October 18, 2019

MI Windows and Doors thanks EPA for requesting our input on the ENERGY STAR® 7.0 revisions. ENERGY STAR has served the Country well by allowing clear choices for better energy efficiency. MI Windows and Doors is one of the top producers of high-quality, energy-efficient windows and sliding patio doors in the USA and welcomes improvements to the program. Our concerns are;

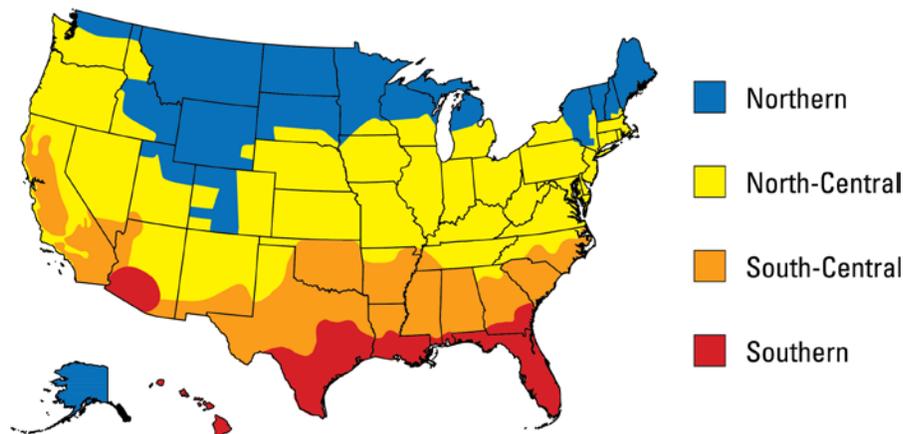
ENERGY STAR market share has stabilized and not increased in the last five (5) years. This indicates a physical and economic barrier to increasing this share. Revising the limits in version 7 will not increase the use of Estar windows but decrease the incentive to buy these more efficient products. EPA should market study this barrier and find ways to increase share without changing U-values and costs to consumers. The real value in ENERGY STAR is how many products are purchased not a simple share gain or reduction.

EPA should also seek more detail for market share in the Northern and North Central zones where heating energy demand is prominent. Our study finds that share is much lower in these zones and simply reacting to the all zones average will hurt energy savings.
